GENERAL APPLICATION

Location Address: 1818 Madison Street, Hollywood, FL 33020

SUBJECT: Site Plan Review for a mixed-use development including 12 residential units and retail space (Madison Apartments).

SUBJECT: Site Plan Review for a residential development including 15 residential units
(Madison Apartments).

1 GROUND FLOOR
3/16" = 1'-0"

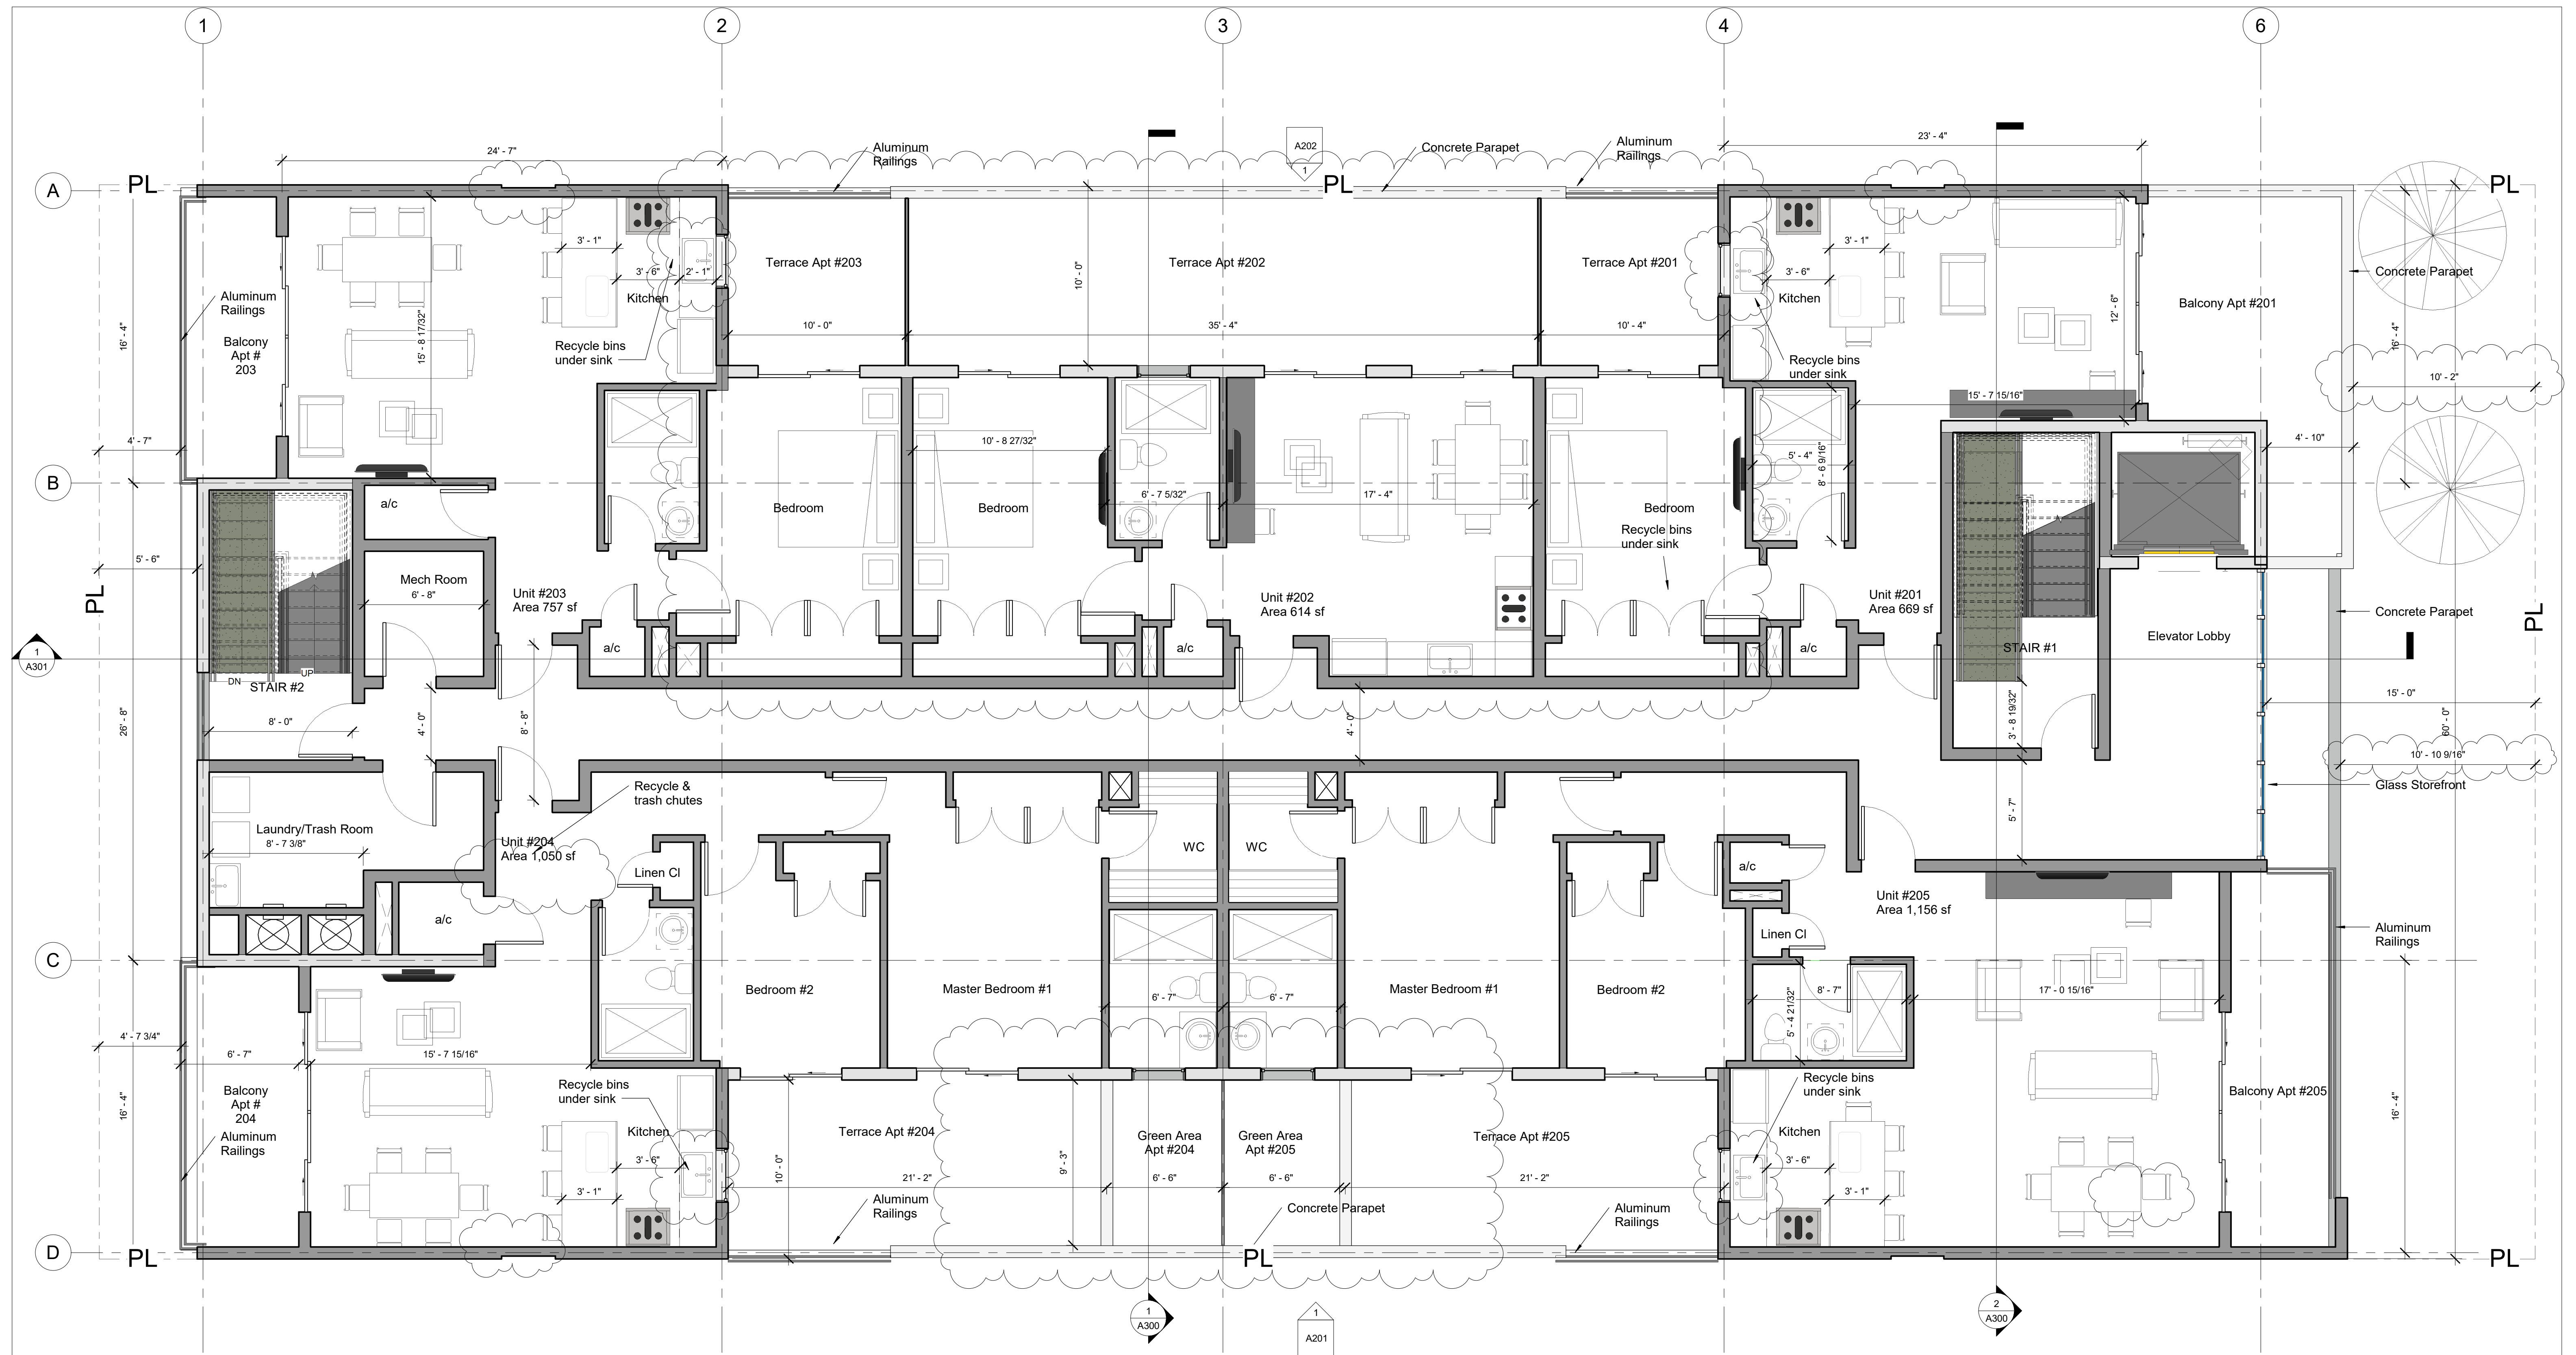
1. Provide project data and green practices on Site Plan, not on cover sheet.
2. Indicate meeting dates (not submittal dates), and subsequent revision dates on Cover Sheet and Title Blocks on all sheets.

1. Project is required to install electric vehicle charging station infrastructure, please see Ordinance O-2016-02.
2. Provide Balcony setback dimensions on Site Plan.

1. Include note on Site Plan stating the maximum foot-candle level at all property lines (maximum 0.5 if adjacent to residential).

1. Indicate on the site plan where the infrastructure necessary for future installation of an electric vehicle-charging station will be located, (See Ordinance O-2016-02).

R: See sheet A100.

R: Provided, see sheet A100.

R: Noted, see sheet A100.

R: Indicated, see sheet A100.

② SOUTH ELEVATION
 1/4" = 1'-0"

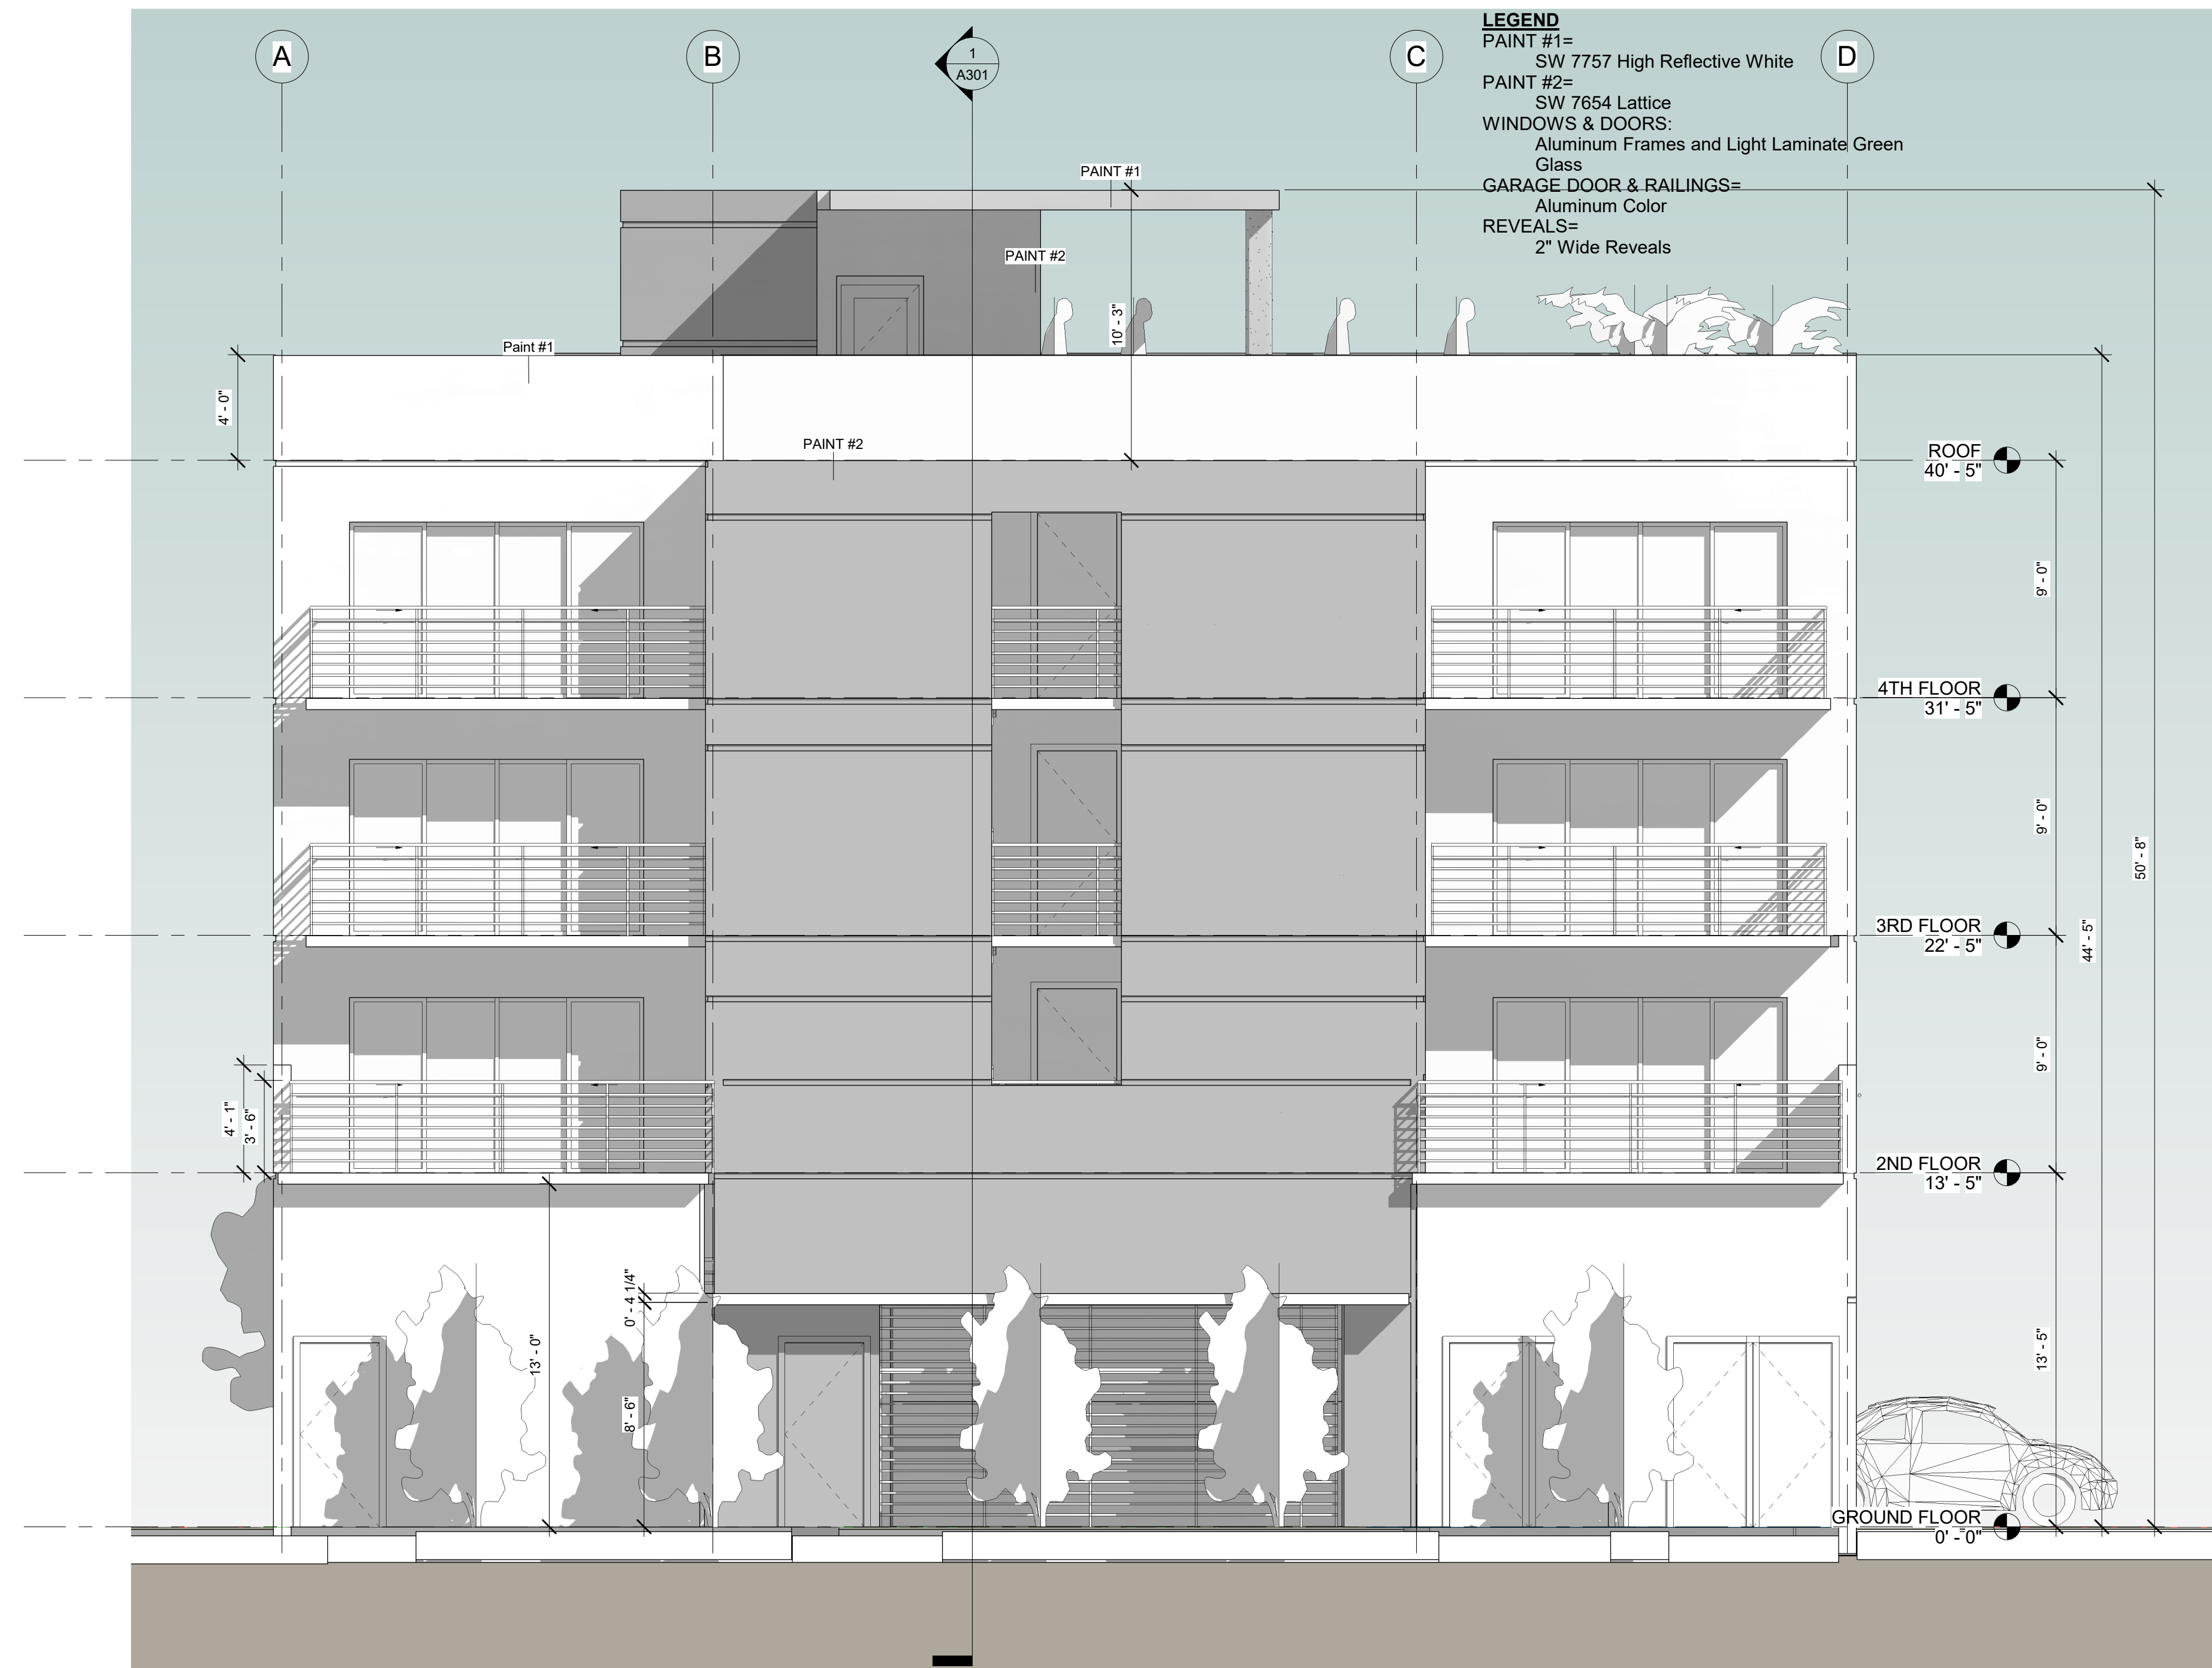
8. South Elevation on Sheet A200 and rendering shows gated driveway opening. Clarify and indicate use of the south driveway opening on plans. Full building parking access connection to alley is not permitted.
